Project: New Student Success Center
LSU at Alexandria
State Project No. 19-602-21-01
WBS No. F.19002361
Architect's Project Number 2021.58

RE: Addendum Number One (1)

SECTION - EQUIPMENT SCREEN

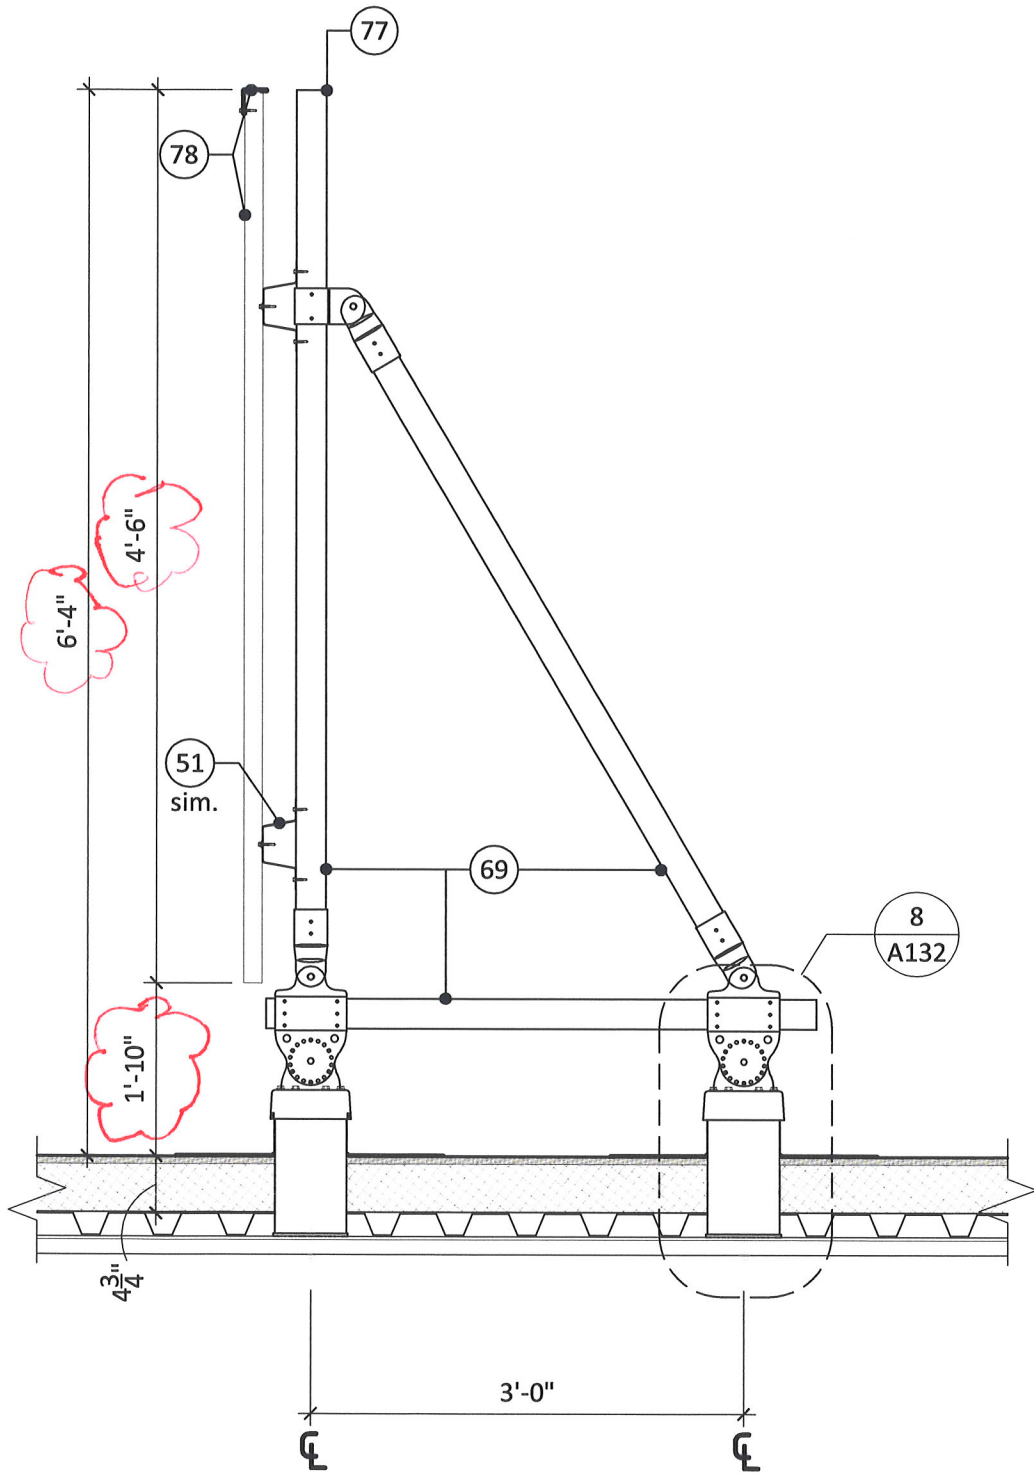
1. Delete Item C.
4. Re: DRAWINGS, Detail 3/A131, Section – Equipment Screen –
 - a. See revised drawing, dated 11.10.23, accompanying addendum.
5. Re: SPECIFICATIONS, Section 10 80 00, Specialties/Miscellaneous, Item 2.12 Motorized Window Shades:
